St.Michael's, Manchester
Proposed Changes, March 2022

This document is a page by page comparison of the approved Section 73 drawings alongside the amended which forms part of the proposed Section 96a Application.

LEVEL B1 PLAN

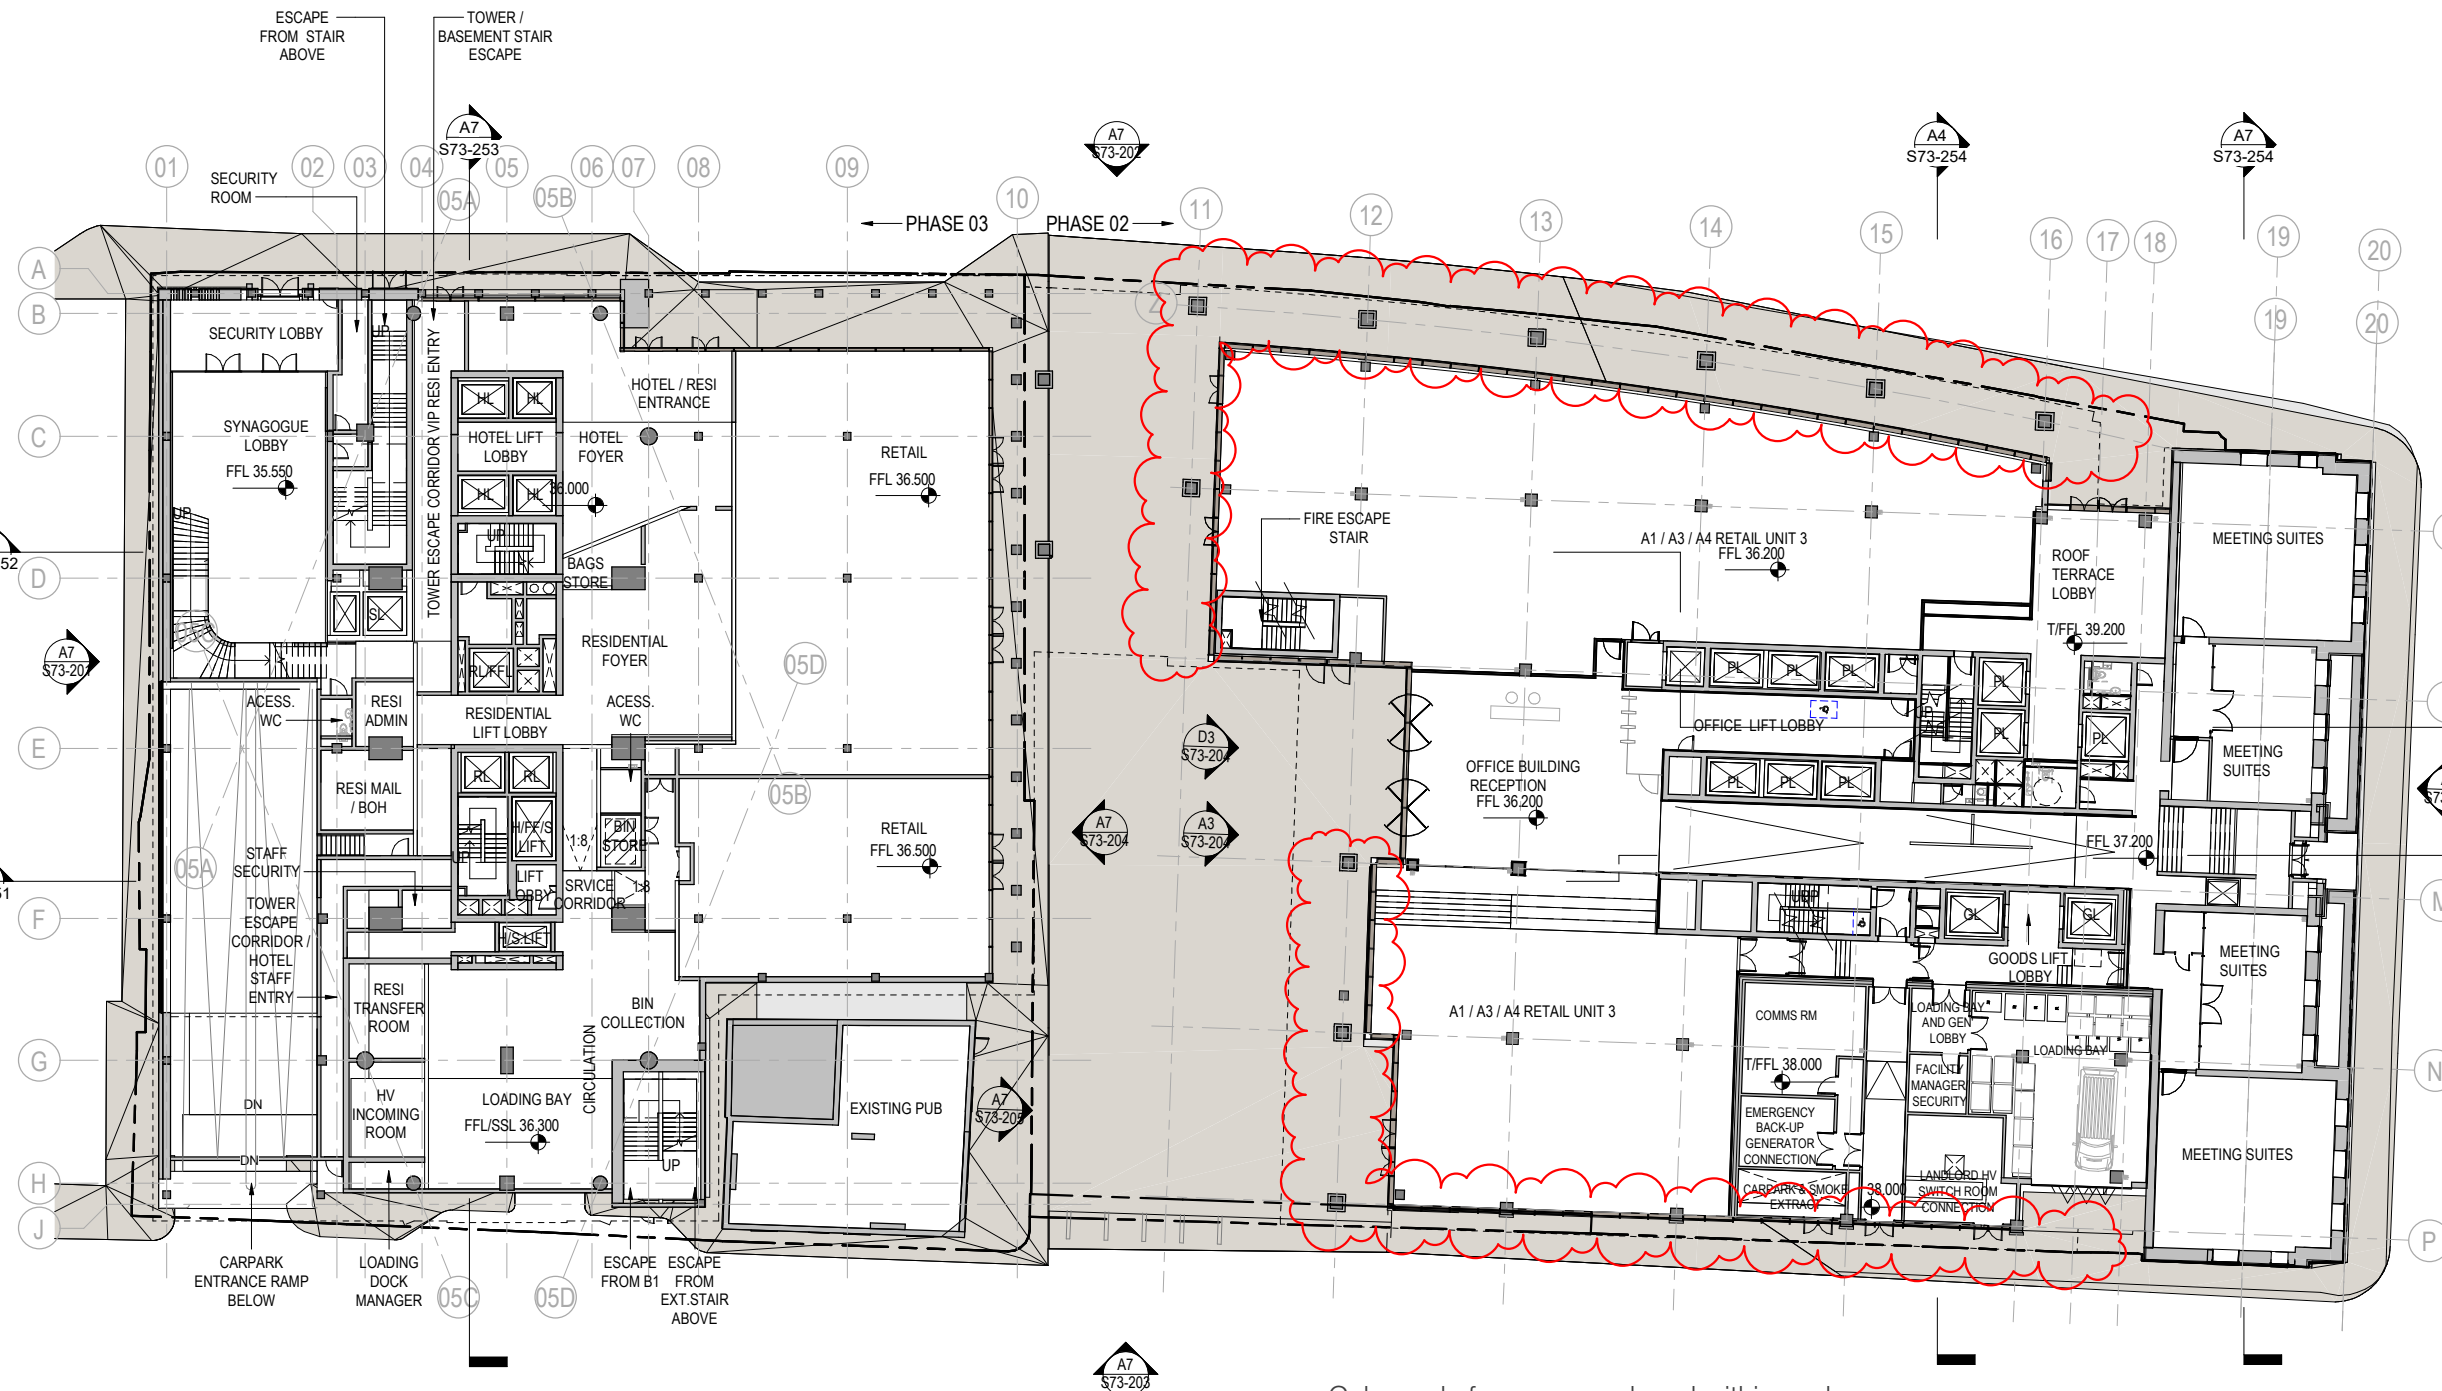
- + Plant areas and car parking re-configured
- + Platform Lift added to retail unit UG-3

GROUND LEVEL GA PLAN

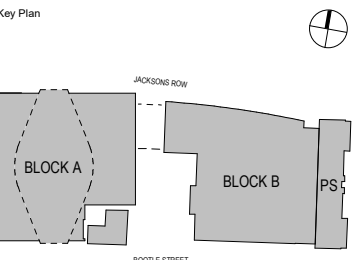
- + Colonnade frequency reduced within each structural bay
- + North West corner pulled out, and North East and South corners pushed in to reposition area to develop repeated glass to glass corner detail

LEVEL 04 GA PLAN

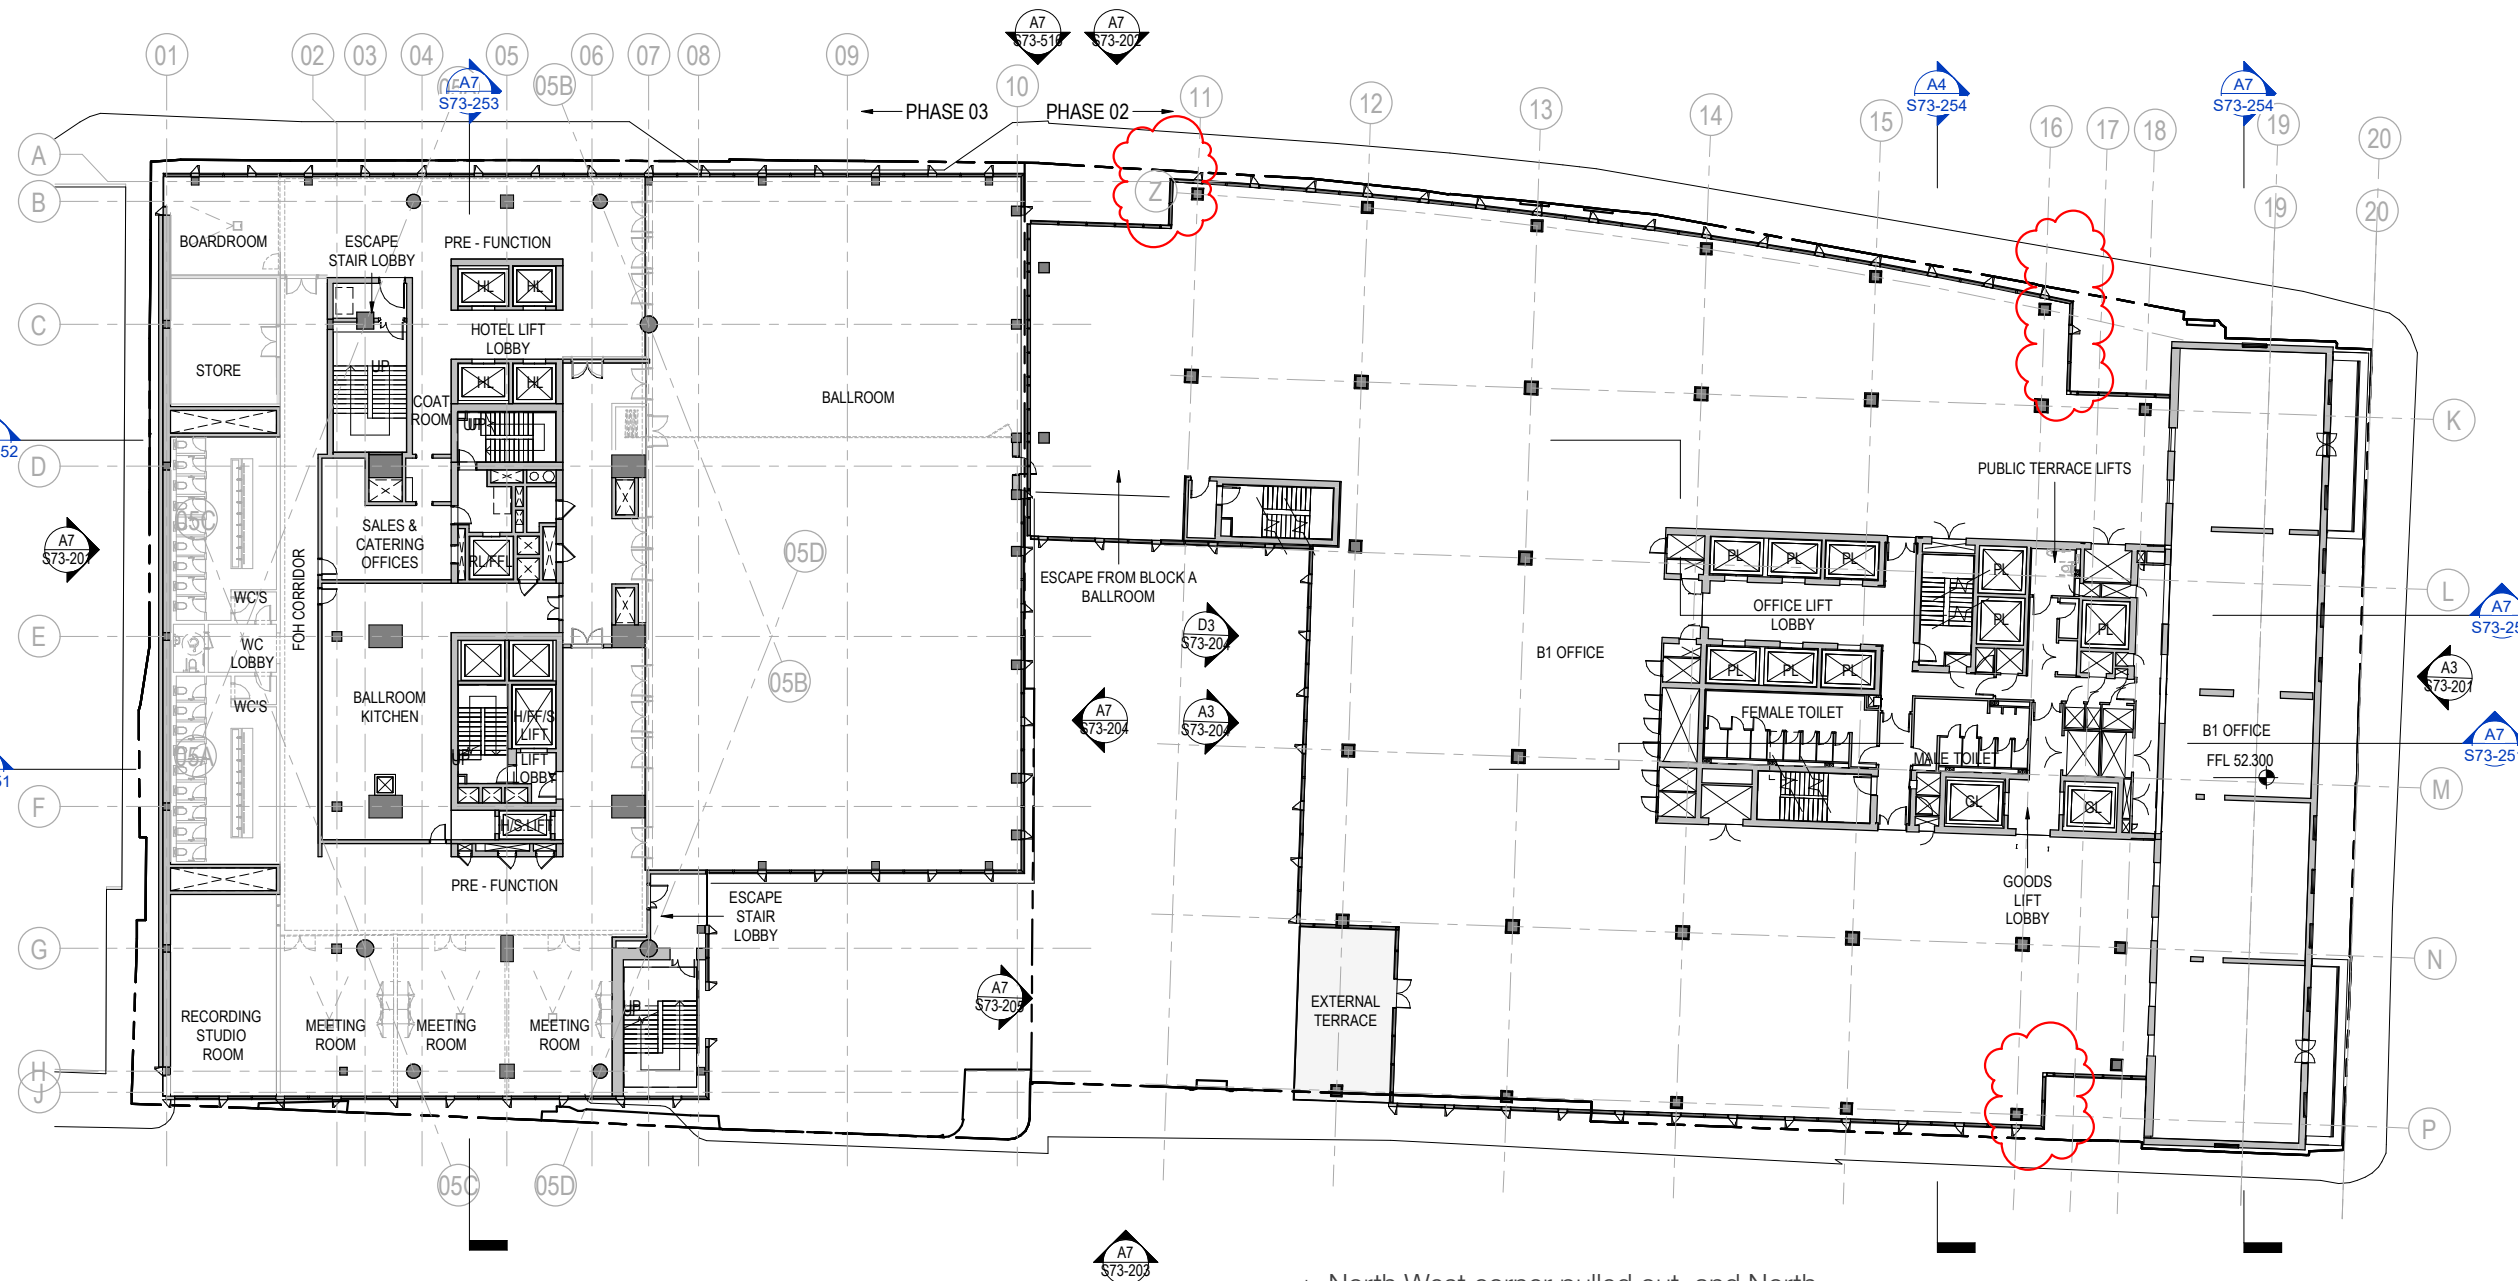
+ North West corner pulled out, and North East and South corners pushed in to reposition area to develop repeated glass to glass corner detail

LEVEL 05 GA PLAN

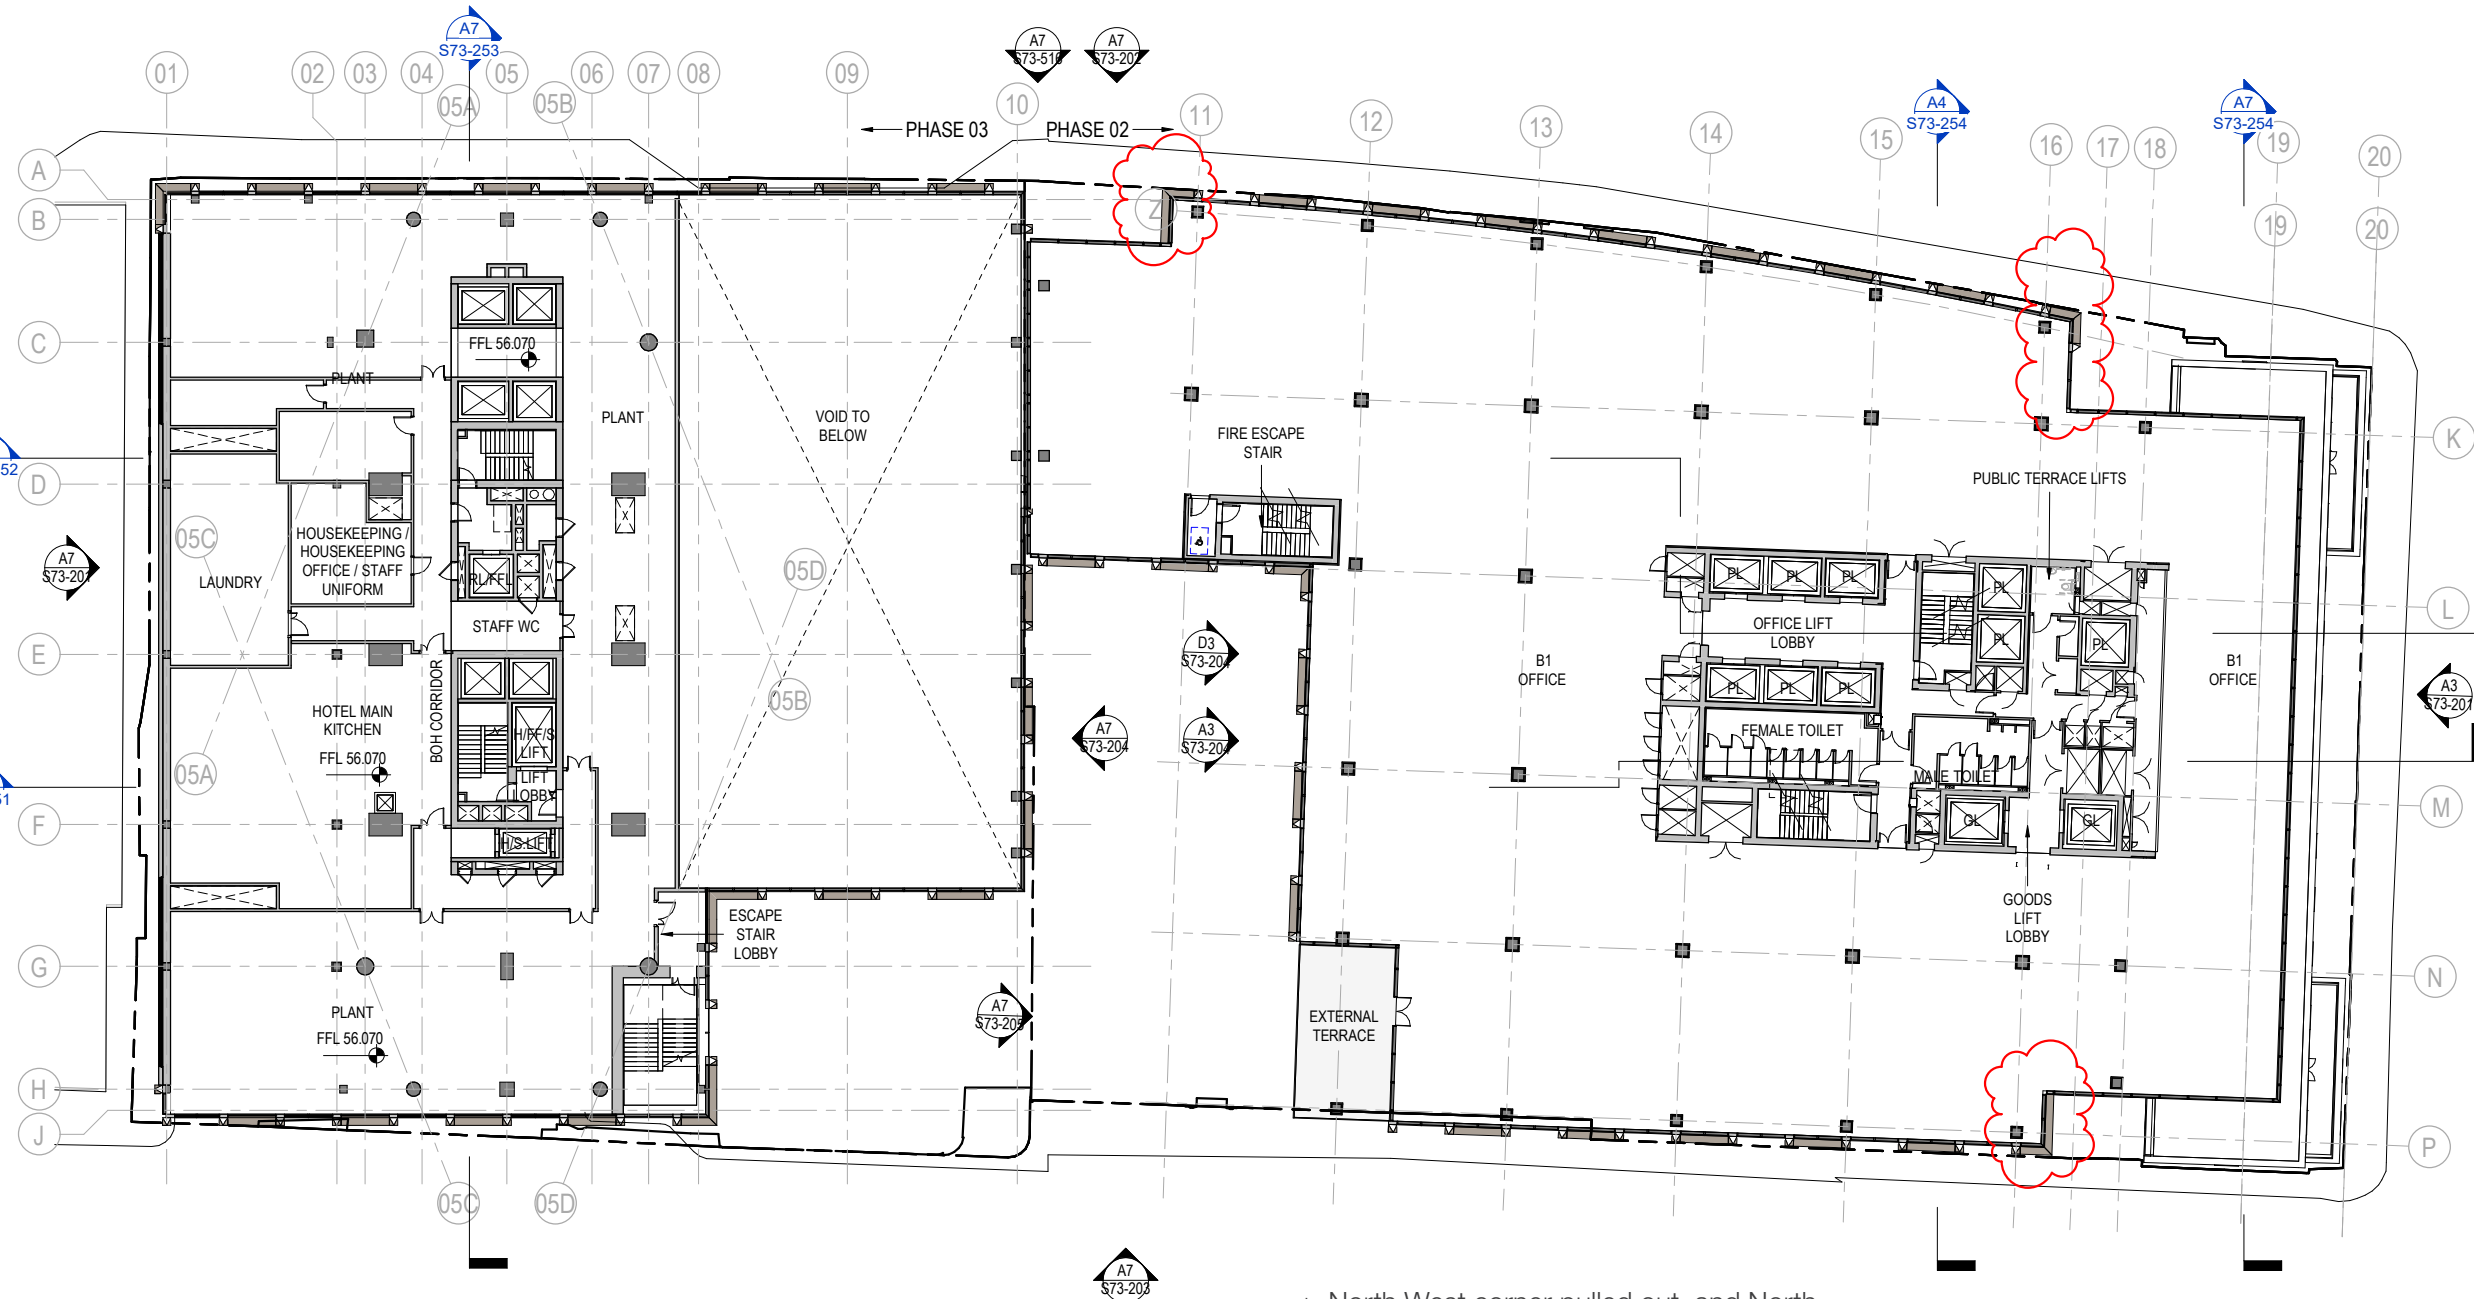
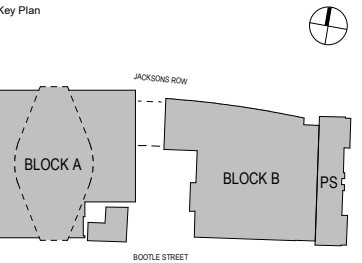
+ North West corner pulled out, and North East and South corners pushed in to reposition area to develop repeated glass to glass corner detail
